2 Type of change

- Change of product label
- Change of packaging label

Product Change Notification					PCN FSO Change of product label		
owner	creation date	release date	released by	change order	rev	page	D10-098-407
kraftal	17.02.2026	18.03.2026	schulejo		A	1 of 2

Current product appearance	New product appearance

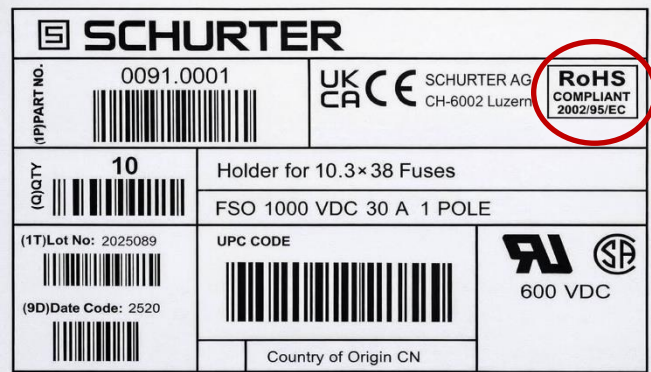
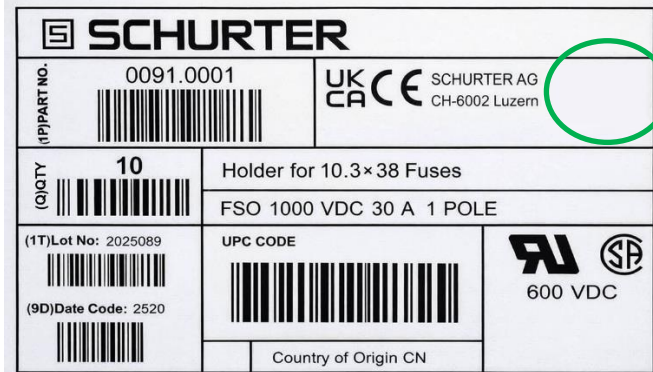
- RoHS logo removed from product and packaging label

| ☒ Form | No action required. Consider new appearance at incoming inspection. |
| ☒ Label | No action required. Consider new appearance at incoming inspection. |
